Development at Gowan Motors  
Site, Naas Road

Stage 1 Road Safety Audit

**Document Ref:** P23063-PMCE-XX-XX-RP-SA-RSA-3\_ZZ\_01

##### 3.1.2 Access at Northwest of Development

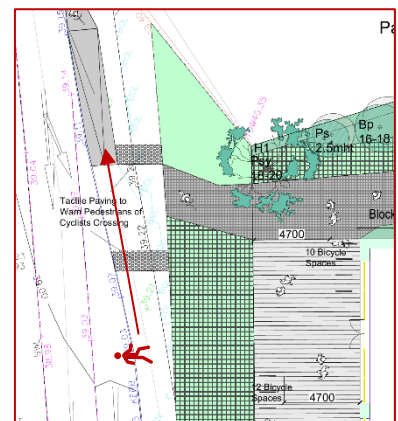
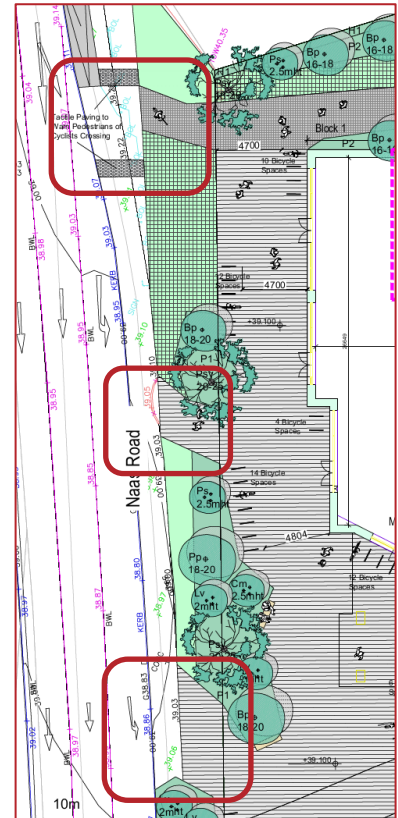
*Summary:* The layout of the access at the northwest of the development, where cyclists are indicated as crossing the existing footpath, is unclear and may be confusing for visually impaired pedestrians.

Tactile paving has been indicated on both sides of the access at the northwest of the proposed development where it is intended that cyclists would travel between the Naas Road and the development's underground Bike Store via this access. A ramp has been indicated at this location to allow cyclists to leave the Naas Road carriageway and enter the development.

Tactile paving has been indicated within the footpath on both sides of this access however the type of tactile paving proposed is unclear. Should 'Ladder and Tramline' tactile paving not be provided on the north-eastern side of the access where the footpath and cycle track transition to a shared path, this may result in visually impaired pedestrians, travelling northeast, inadvertently descending the ramp and entering the cycle track where they are at risk of being struck by a cyclist.

In addition, should warning tactile paving not be provided on the south-western side of the access, there is a risk that visually impaired pedestrians may be insufficiently aware that they have entered/exited an area shared with cyclists, increasing the risk of cyclist-pedestrian collisions.

'Ladder and Tramline' tactile paving, of an appropriate depth, should be provided on the north-eastern side of the access and warning tactile paving should be provided on the south-western side of the access where the segregated facilities transition to the shared surface.

### 3.1.3 Safe Zone for Visually Impaired Pedestrians

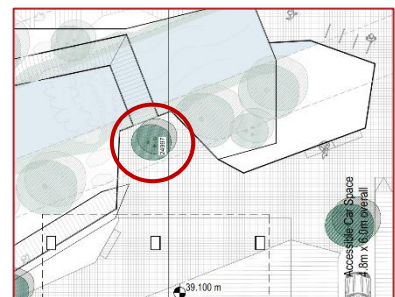
*Summary: A designated 'safe zone' for visually impaired pedestrians has not been indicated within the development's shared surface, particularly where vehicles share the space with pedestrians and cyclists.*

A shared surface which would be traversed by vehicles, cyclists, and pedestrians has been indicated within the proposed development, however, a designated 'safe zone' has not been provided within this surface for visually impaired pedestrians where they can travel without having to share space with motorised vehicles. The absence of a 'safe zone' within areas shared by all road users may lead to an increased risk of vehicle-pedestrian collisions and, in addition, lead to visually impaired pedestrians being unable to safely and independently navigate through the development.

A designated 'safe zone' denoted by, for example, a strip of guidance tactile paving, or similar measures, should be provided to guide visually impaired pedestrians through areas shared with motorised vehicles.

### 3.1.5 Tree Pit within Existing Footpath

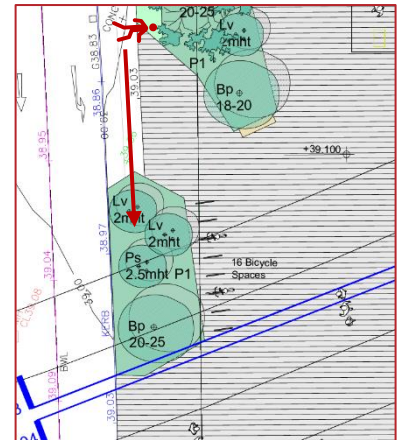
*Summary:* The pedestrian desire line along the existing footpath on the eastern side of the Naas Road would be blocked by a tree pit.

A tree pit has been indicated within the existing footpath on the Naas Road at the southwest of the proposed development. This would obstruct the desire line of pedestrians travelling along the existing footpath on the Naas Road and may lead to pedestrians travelling over the tree pit, rather than diverting around it and into the development, where there is a risk of trips and falls.

The tree pit should be removed or relocated such that the pedestrian desire line along the footpath is not obstructed.

### 3.1.6 Dropped Kerb at Mobility Parking Space

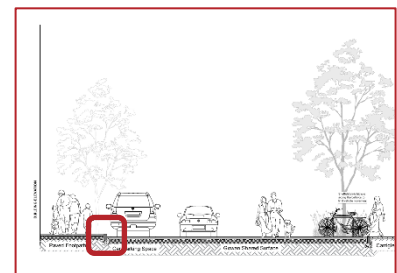
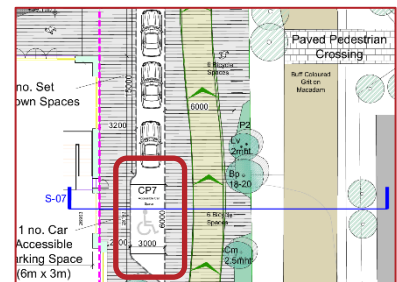
*Summary:* No dropped kerb, and tactile paving has been indicated at the mobility parking space within the proposed development.

A mobility impaired parking space has been indicated within the proposed development to the east of Block 2. Cross-section 'S-07' indicates that a kerb would be located to the rear of the parking space between the space and the adjacent shared surface. No dropped kerb has been indicated adjacent to the mobility parking space. This would lead to mobility-impaired vehicle occupants having to travel within the area shared with motorised vehicles to a suitable access location, where they are at risk of being struck by a vehicle.

A dropped kerb, and associated tactile paving, should be provided adjacent to the mobility impaired parking space.

### 3.1.7 Transition between Public Footpath and Development’s Shared Surface

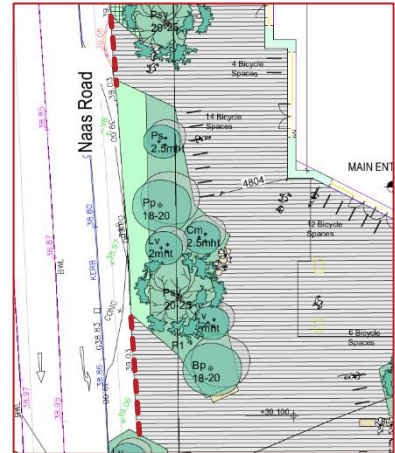
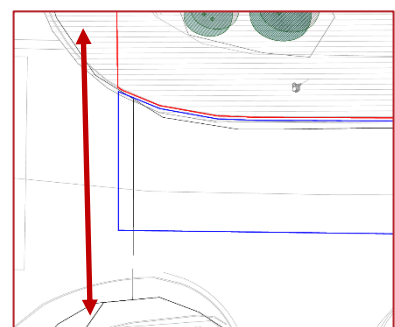
Summary: It is unclear how the development’s shared surface will be delineated from the existing footpath on the Naas Road, which may lead to visually impaired pedestrians entering an area shared with cyclists.

The proposed development would be accessible to pedestrians traveling along the eastern side of the Naas Road at a number of locations. It is unclear if measures to delineate the development’s shared surface from the public footpath would be provided where the footpath on the Naas Road intersects the shared surface within the development. Should none be provided, this may lead to visually impaired pedestrians inadvertently entering the shared surface within the development where they are at risk of being struck by a cyclist.

Delineation measures, such as warning tactile paving or contrasting surface material/colour, should be provided to advise visually impaired pedestrians, travelling on the Naas Road, of the development’s shared surface.

### 3.1.8 Pedestrian Crossing of Carriglea Industrial Estate at Junction with Naas Road

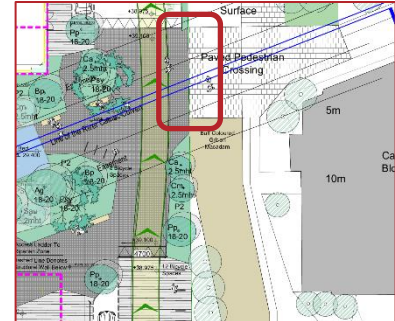
Summary: There is no pedestrian crossing provided, nor has one been indicated, across the access road to the Carriglea Industrial Estate at its junction with the Naas Road.

There is no existing pedestrian crossing at the access road to the Carriglea Industrial Estate at its junction with the Naas Road, nor has one been indicated on the development’s site layout drawing.

However, an additional drawing has been provided which indicates improvements to the Carriglea Estate Access Road, which include the provision of a signalised pedestrian crossing at this location. It is, however, unclear if this crossing would be constructed, and therefore in operation, at the time of the development’s opening.

If no pedestrian crossing is provided at the access road, this could lead to mobility and visually impaired pedestrians experiencing difficulties crossing the road to access the development from the southwest resulting in personal injuries as pedestrians attempt to ascend/descend the kerbs.

In addition, the absence of a crossing may lead to pedestrians crossing at locations where drivers may be less attentive to them, increasing the risk of vehicle-pedestrian collisions.

A pedestrian crossing should be provided at the access road to the Carriglea Industrial Estate, and be in operation at the time of the development’s opening.

### 3.1.10 Gullies at Vertical Changes in Level

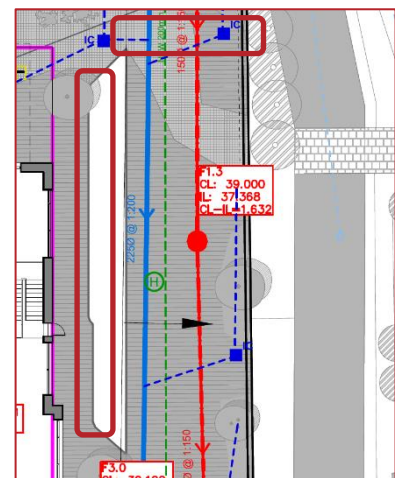
**Summary:** *Gullies have not been indicated within the proposed development, particularly at locations where vertical changes in level are proposed (e.g. raised tables, kerbs etc.), and it is unclear if the shared surface will sufficiently shed surface water at these locations.*

Information relating to the drainage provision within the proposed development has been provided however there does not appear to be any gullies indicated within the development. The development would make use of SuDS drainage, however it is likely that gullies would be required at vertical changes in level such as at the proposed raised table to the east of the River Camac and where kerbs have been indicated at car parking spaces and set down areas.

If sufficient drainage measures are not provided at these locations there is an increased risk of ponding which may lead to loss of traction for vehicles and cyclists, and slips and falls for pedestrians, particularly during times of cold and icy weather, resulting in material damage to vehicles and personal injuries to pedestrians and cyclists.

Sufficient drainage measures should be provided throughout the proposed development to prevent ponding.

### 3.1.11 Visibility Splay

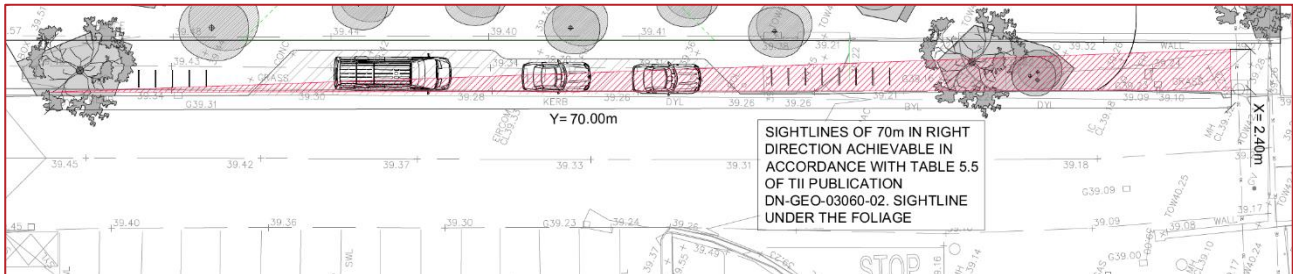
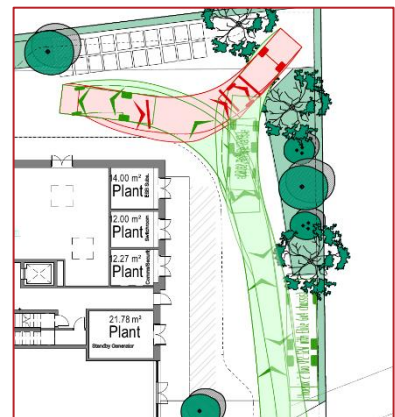
**Summary:** The visibility splay for drivers exiting the development onto the Carriglea Industrial Estate Access Road is indicated as passing through trees/vegetation, bicycle parking stands and the set down area.

A visibility splay has been provided for drivers exiting the proposed development onto the Carriglea Industrial Estate Access Road. The visibility splay is indicated as passing through trees/vegetation, bicycle parking stands and the set down area. While there is a note on the drawing indicating that a driver's visibility would be below the foliage of the trees, visibility for an exiting driver towards an oncoming vehicle may be restricted by bicycles parked at the bicycle stands or vehicles parked within the set down area. This could lead to drivers exiting the development when it is unsafe to do so resulting in side-on collisions with vehicles on the Carriglea Industrial Estate Access Road.

The visibility splay for drivers exiting the development should be clear of vegetation and items of roadside furniture.

### 3.1.12 Swept Path of Large Vehicles

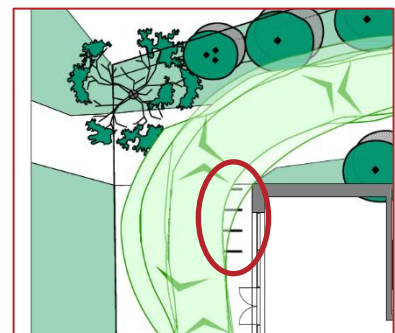
**Summary:** The swept path of some vehicles is indicated as conflicting with trees and bicycle parking stands.

Swept paths of a refuse truck and fire tender travelling through the development's vehicular route have been provided.

The swept path of a refuse truck is indicated as conflicting with an area that may include tree canopies as it traverses through the development. While this is unlikely to lead to material damage to the vehicle it may lead to branches of trees being knocked into the carriageway or shared surface where they may present hazards to smaller vehicles, resulting in material damage if struck, or non-motorised road users, resulting in personal injuries.

Similarly, the swept path of a fire tender is indicated as passing through bicycle parking stands adjacent to Block 1 which would result in material damage to the bicycle parking stands, or bicycles parked there if occupied.

All vehicles should be able to safely travel through the development without conflicting with vegetation or items of roadside furniture.

### 3.1.14 Location of Public Lighting Columns

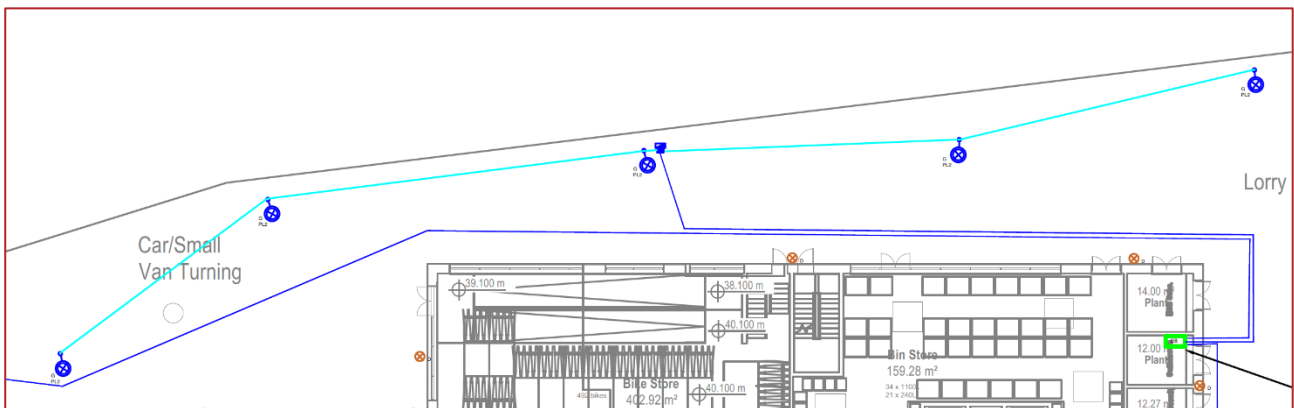
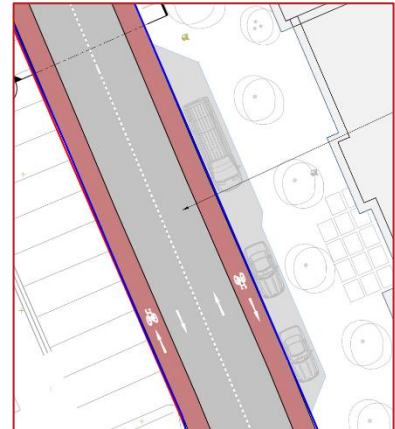
*Summary: Some of the public lighting columns within the proposed development have been indicated within the vehicle route, adjacent to trees and at building access.*

A number of public lighting columns have been indicated throughout the proposed development. Although unclear, some of these appear to be located within the vehicular route along the eastern and northern sides of Blocks 1 and 2, and within the car/small van turning circle, where they would be at risk of being struck by a vehicle resulting in material damage.

Similarly, some public lighting columns have been indicated where they would be located adjacent to trees. The height of the luminaires of the lighting columns, relative to the tree canopies, is unclear at this early stage in the design process however, should the tree canopy and luminaires be at the same height, the tree canopies may block the luminaire preventing it from sufficiently illuminating the development. This could lead to dark spots within the development resulting in reduced inter-visibility between road users and an increased risk of collisions.

The public lighting columns within the proposed development should be located outside the vehicular routes and where they would not be impeded by the canopy of adjacent trees.

### 3.1.15 Cycle Lane Adjacent to Set Down Area

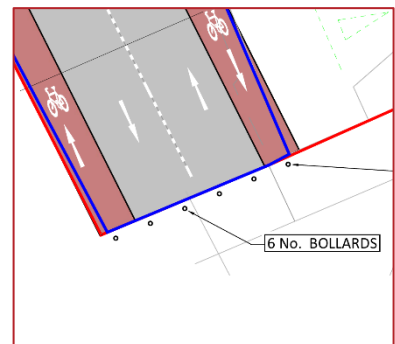
*Summary: Vehicle occupants opening car doors when stopped in the set down area may present a hazard to cyclists within the inbound cycle lane.*

It is proposed to upgrade the road layout on the Carriglea Industrial Estate Access Road to provide cycle lanes in each direction. The inbound cycle lane is indicated as running directly adjacent to the proposed development's set down area in front of Block 2. A buffer zone has not been indicated between the cycle lane and set down area and this could lead to the occupant of a vehicle within the set down area opening the door of their vehicle into the path of an oncoming cyclist resulting in collisions and personal injuries, or to cyclists suddenly swerving into the adjacent traffic lane to avoid an open door where there is an increased risk of being struck by a vehicle.

A buffer zone should be provided between the cycle lane and set down area such that an open vehicle door would not encroach into the cycle lane.

### 3.2.1 Width of Pedestrian Crossings

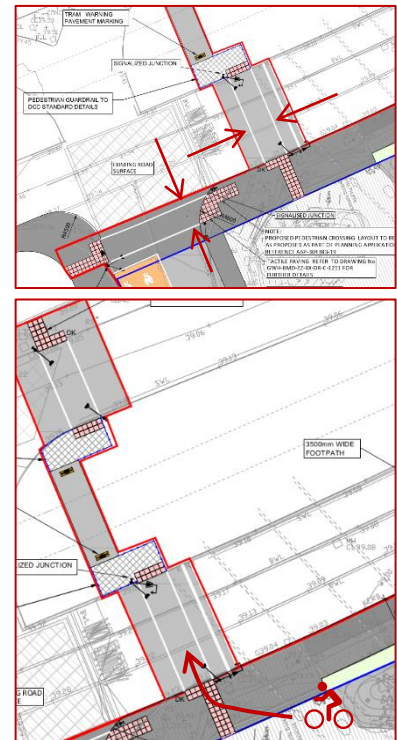
*Summary:* Pedestrian crossing widths may be insufficient to safely accommodate the likely volumes of crossing pedestrians and cyclists.

The new signalised pedestrian crossings on the Naas Road, and across the development's access road, are indicated as being approximately 2.4m wide. Pedestrian crossings of this width in an urban area may not sufficiently accommodate the volume of pedestrians using the crossing, particularly during peak times.

Pedestrian crossings which are not wide enough to accommodate the volume of pedestrians using them may result in pedestrians crossing outside the extents of the crossing increasing the risk of vehicle/pedestrian collisions.

This issue would be exacerbated should cyclists also use the pedestrian crossing of the Naas Road as it is likely to create an attractive route for cyclists when travelling to/from the proposed development.

The pedestrian crossings should be wide enough to cater for the expected/likely volumes of pedestrians and cyclists during peak times (the "Design Manual for Urban Roads and Streets (DMURS)" suggests that crossings in "Urban Centres" should be a minimum of 4m wide).

In addition, the crossing of the Naas Road should be amended to a Toucan crossing to support cyclist use.

3.1.14	YES	YES		
3.1.15	YES	YES		
3.1.16	YES	YES		
3.2.1	YES	NO	WIDTH OF THE CROSSINGS WILL BE INCREASED AS RECOMMENDED. HOWEVER, THE PROPOSAL FOR THE TOUCAN CROSSING IS CONTRARY TO DCC PREFERENCE FOR CYCLISTS TO USE THE MAIN ACCESS ROADS. CYCLISTS TRAVELLING FROM THE CITY WILL TRAVEL ON THE WESTBOUND CARRIAGEWAY AND TURN ONTO THE CYCLE LANE ON THE ACCESS ROAD. CYCLISTS LEAVING THE DEVELOPMENT WILL USE THE CYCLE LANE ON THE ACCESS ROAD AND JOIN THE NAAS ROAD FROM THE UPGRADED JUNCTION	Yes

### 3.2.2 Location of Proposed Sign

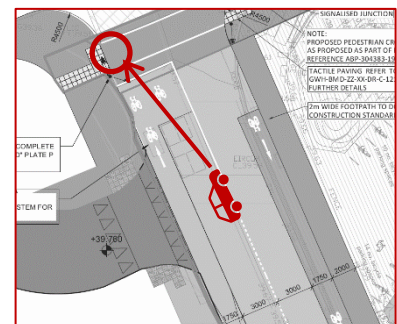
*Summary:* The proposed "Cycle Track End" sign may be located such that it would impede a driver's visibility towards the signal head.

A new "Cycle Track End" sign (RUS 009) has been indicated on the western side of the access road to the proposed development. The exact location of the sign is unclear, however it appears that it would be located immediately upstream of the primary traffic signal pole. This may result in the sign partially blocking the signal aspects and impeding an approaching driver's visibility towards the signal head. Reduced visibility to the primary signal head may lead to drivers being insufficiently aware of a red signal at the junction, reducing the time they would have to react, resulting in possible overshoot type incidents and collisions with pedestrians using the crossing, or side-on collisions with vehicles on the Naas Road.

The sign should be relocated, so as not to restrict an approaching driver's visibility towards the signal head.

### 3.2.3 Guardrail Setback

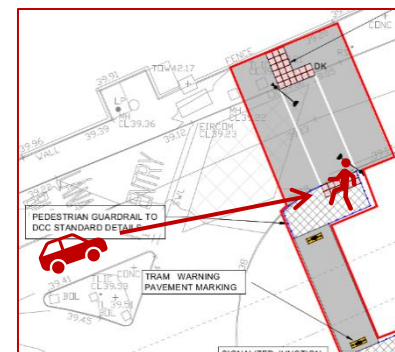
*Summary: It is unclear if the proposed pedestrian guardrails would be sufficiently setback from the edge of the carriageway and Luas tracks.*

Pedestrian guardrails have been indicated at the edge of the refuge islands within the proposed pedestrian crossing of the Naas Road.

It is unclear if the guardrails would be sufficiently setback such that they would provide the necessary clearance to the edge of the carriageway and the Luas track. If the pedestrian guardrails are not sufficiently setback, there is an increased risk of vehicle strikes and material damage.

The pedestrian guardrails should be setback a minimum of 450mm from the edge of the carriageway and Luas tracks.

### 3.2.5 Awareness of the Tramline Crossing

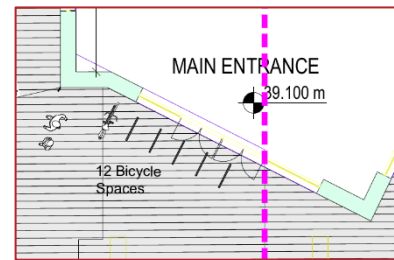
*Summary:* Visually-impaired pedestrians may be insufficiently aware of the crossing of the Luas tracks.

The proposed crossing of the Naas Road includes a crossing of the Luas tracks, however no tactile paving has been indicated on either side of the Luas line to advise visually-impaired pedestrians of the upcoming hazard. This may lead to visually-impaired pedestrians being insufficiently aware of the tracks, resulting in them inadvertently entering the tracks where there is an increased risk of being struck by a Luas.

Measures should be provided on both sides of the tram crossings to advise visually impaired pedestrians of the Luas track.

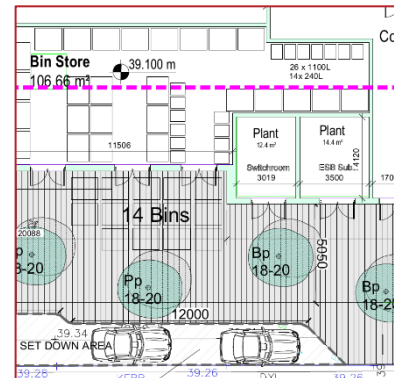
4.1.1 Bicycle parking stands have been indicated within the development's shared surface adjacent to the main entrance to Block 1 such that they would block a pedestrian's access/egress to/from Block 1, particularly when the stands are occupied. The bicycle parking stands should be relocated where they will not present an obstacle to non-motorised road users.

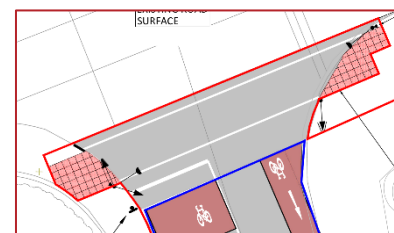
4.1.2 Space for the storage of fourteen bins has been indicated within the development's shared surface at the edge of the Carriglea Industrial Estate Access Road such that they would block access/egress to/from Block 2. The bin storage area should be relocated where it would not block access, or present obstacles, for non-motorised road users.

4.1.3 There are inconsistencies between some of the site layout drawings provided. For example, the Ground Floor Plan (Drawing GWH-HKR-XX-00-DR-A-0200) and Ground Floor Masterplan (Drawing 22-579-SDA-PD-DR-GF-001) differ in some locations. Two motorcycle parking spaces have been indicated adjacent to the lorry turning area which have not been indicated on the Ground Floor Plan. Similarly, the layout of the three parking spaces adjacent to the eastern side of Block 1 are not indicated in detail on the Ground Floor Plan. To avoid confusion during construction, the layout of the proposed development should be consistent throughout all drawings.

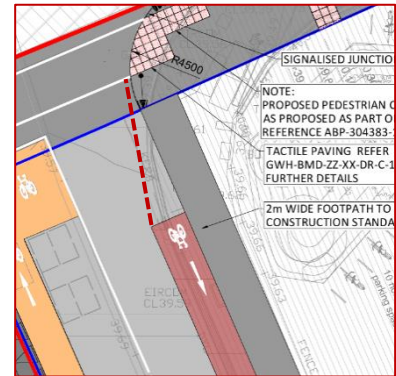
- 4.2.1 The cycle lane indicated on the eastern side of the development access road commences downstream of the access road's junction with the Naas Road. This may lead to cyclists and drivers being insufficiently aware of the cycle lane when entering the access road and adopting a position in the carriageway that would fail to correctly guide or direct users to the correct facility downstream.

The cycle lane should be extended to the Naas Road via an appropriate taper with a dashed line road marking to better advise drivers of the cycle lane and to guide cyclists into the cycle lane.

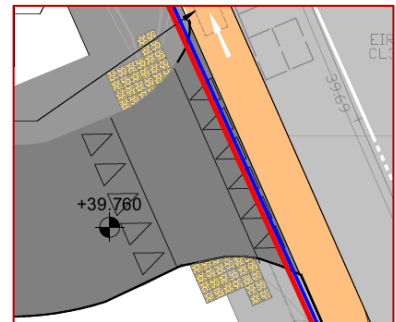
- 4.2.2 The tactile paving layout indicated at the crossing of the access on the western side of the development access road is incorrect for an in-line uncontrolled pedestrian crossing. The tactile paving layout at this location should be amended, and the stem indicated removed, to provide tactile paving with a depth of at least 1.2m across the full width of the crossing.

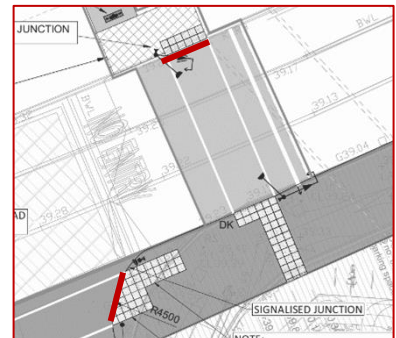
- 4.2.3 The label "DK" has been indicated adjacent to a number of the pedestrian crossing points. It is assumed that this text denotes that a dropped kerb would be provided at these locations. However, it is unclear if a dropped kerb would be provided where this label has not been indicated, such as at the refuge island crossings and the crossing of the development access road. Dropped kerbs should be provided at all pedestrian crossing points.
